To: Susan Becker, TUV Product Service Inc
From: Linda Elliott
lelliott@fcc.gov
FCC Application Processing Branch

Re: FCC ID OLZR4170
Applicant: New Japan Radio Co. Ltd.
Correspondence Reference Number: 8922
731 Confirmation Number: EA94843
Date of Original E-Mail: 07/27/1999

The Position of FCC ID Number

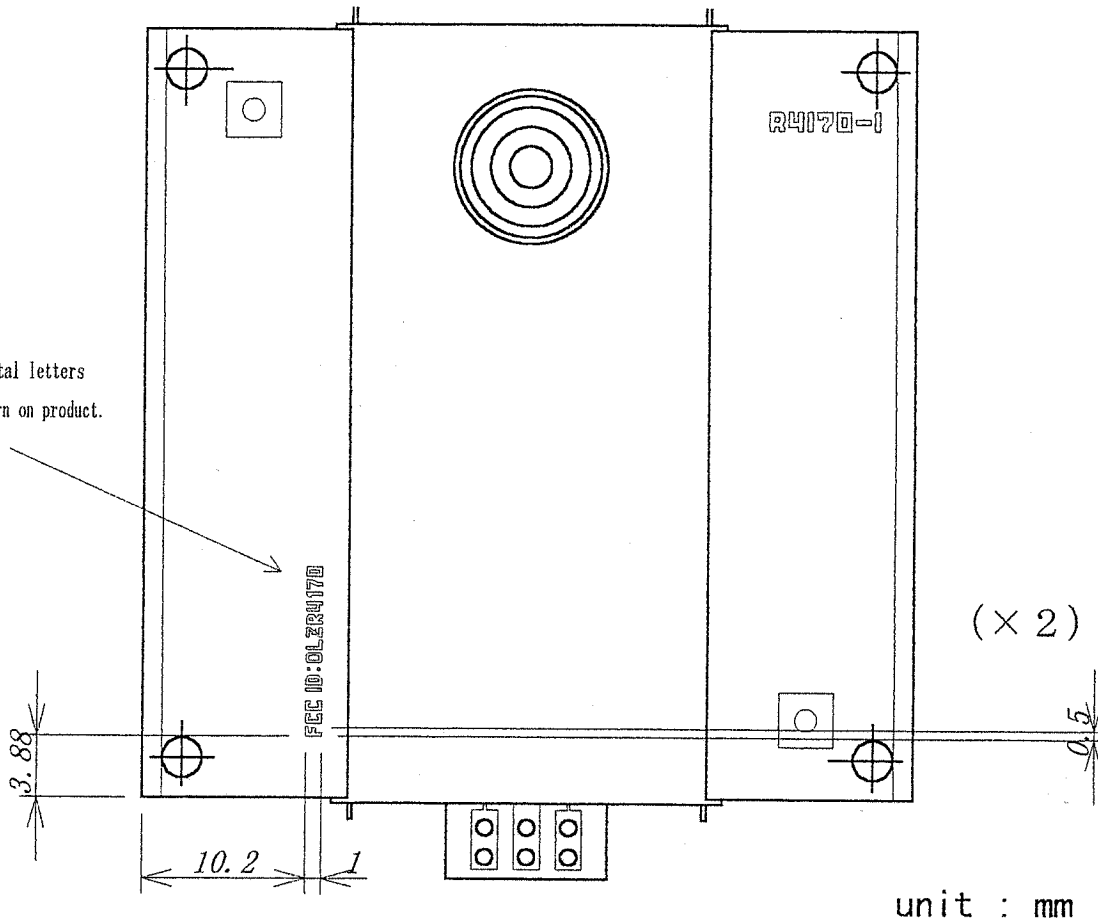
The FCC ID is not shown on the drawing of the identification label. Submit a revised identification label, via your electronic application EA94843, as appropriate. Also, indicate where the compliance statement will be placed on the device, pursuant to Section 15.19(a)(3) of the Rules. If the device is too small to be placed on the device, then it must be shown in the users manual. See Section 2.1033(b)(3) of the Rules.

The FCC ID is illustrated with capital letters etched pattern on product.

The Position of FCC ID Number

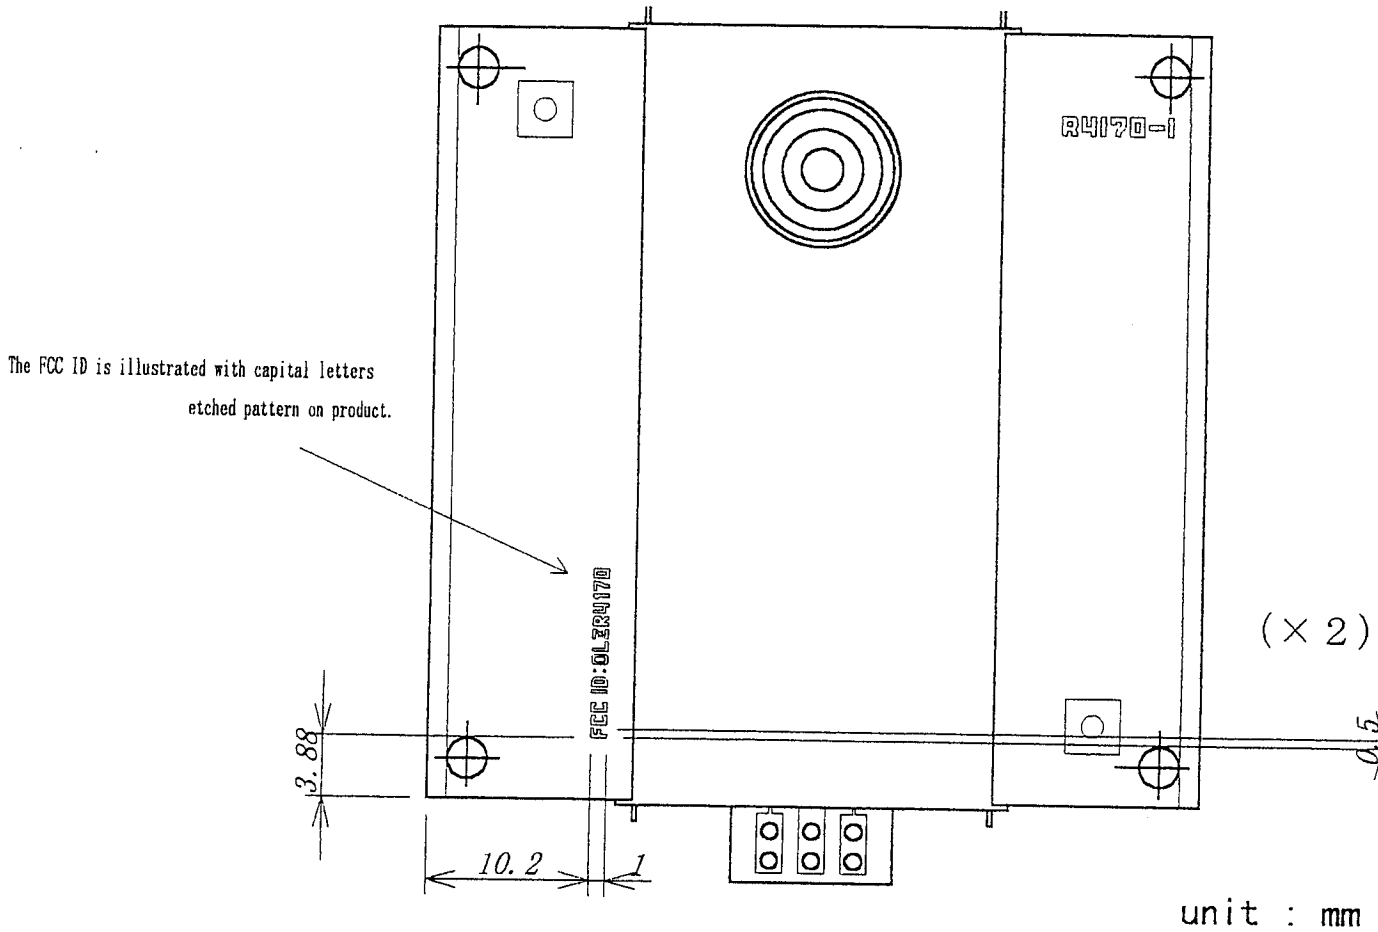
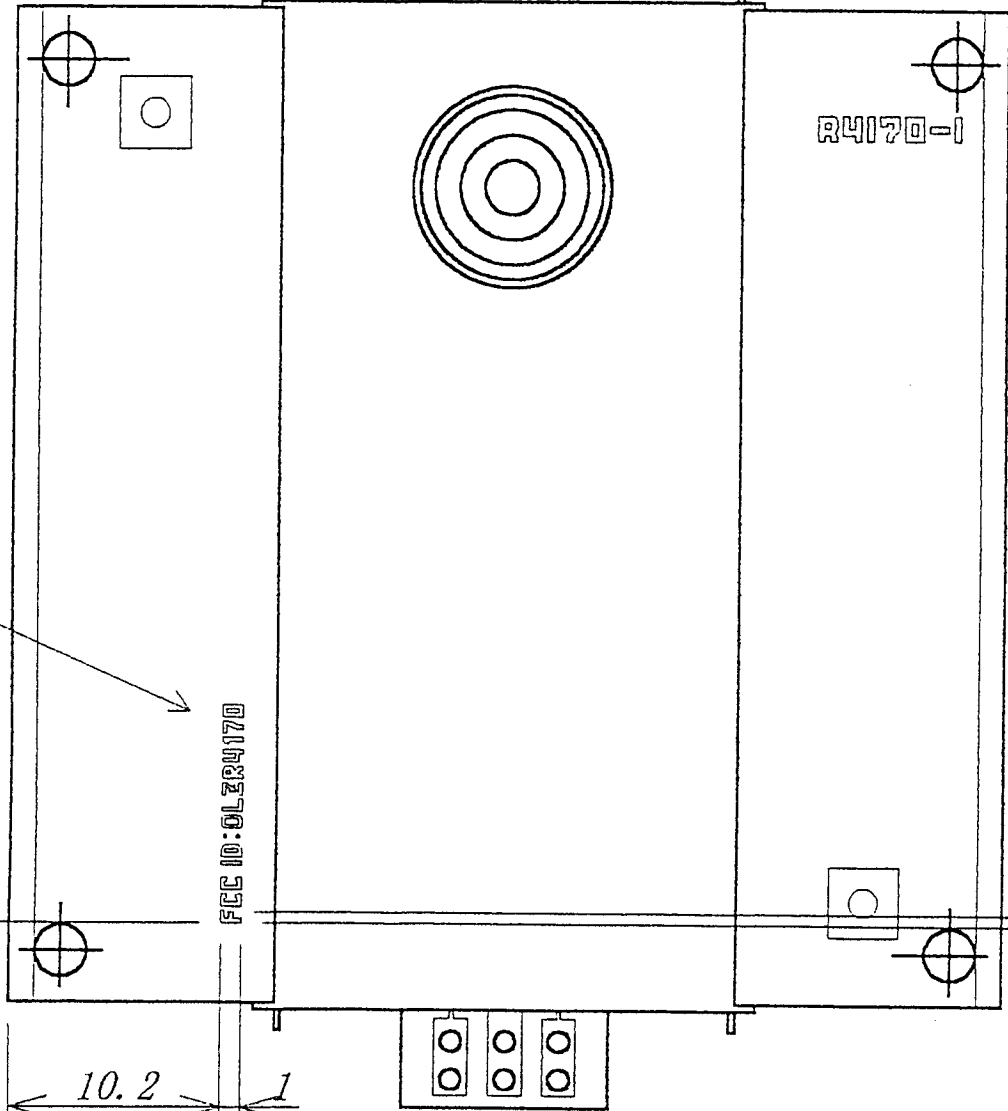
uploaded to the FCC 8-~~6~~-99.
Additional Requested information.
A clearer picture of FCC ID Placement.
